State of New Mexico
Energy, Minerals and Natural Resources

Form C-103
Revised July 18, 2013

WELL API NO. 30-025-37624
5. Indicate Type of Lease STATE ☒ FEE ☐
6. State Oil & Gas Lease No.
7. Lease Name or Unit Agreement Name ANTELOPE RIDGE UNIT
8. Well Number #011
9. OGRID Number 16696
10. Pool name or Wildcat ANTELEPE RIDGE; ATOKA (GAS) 70360

OXY PROPOSES TO PLUG AND ABANDON THE SUBJECT WELL. THIS IS A REFILING OF A PA NOI APPROVED IN 2022. THE PREVIOUS FILING IS ATTACHED AND INCLUDES THE CURRENT WELLBORE, PROPOSED WELLBORE, AND PA PROCEDURE.

OXY USA WTP LP- Proposed

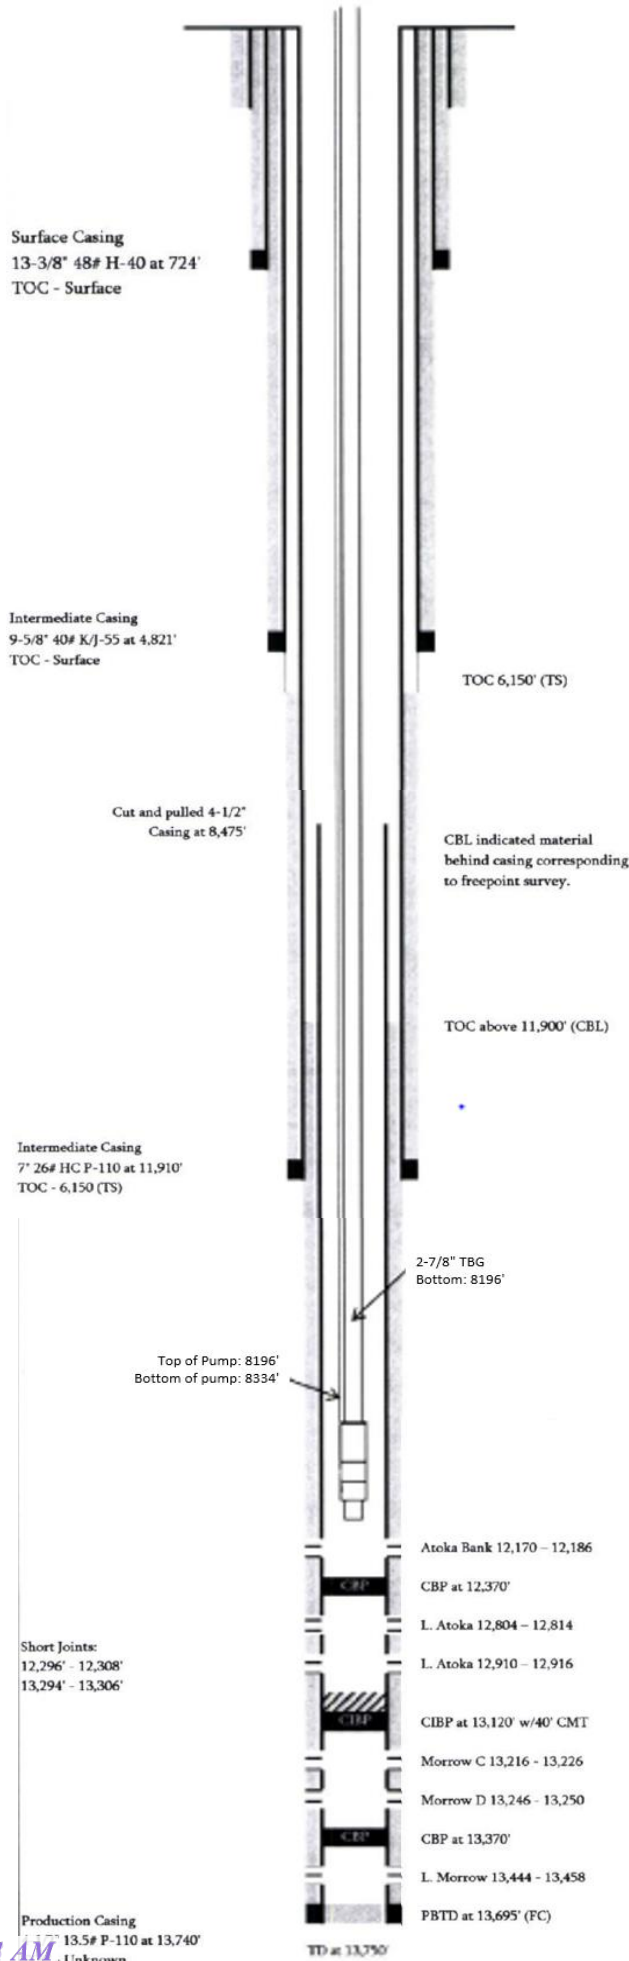
1. CIBP @ 12120' -**Test Casing 500psi/30min - Run CBL to surface -DB** 5 SX CMT . WOC AND TAG
2. SPOT 45 SX CL H CMT FROM 11338' TO 11960'. WOC AND TAG.
3. SPOT 25 SX CL H CMT FROM 8475'-8350'. WOC AND TAG.
4. PERF AND SQZ 60 SX CL C CMT 5145'-4771'. WOC AND TAG.
5. PERF AND CIRC 135 SX CL C CMT 902'-SURF'. WOC AND VERIFY TO SURF.
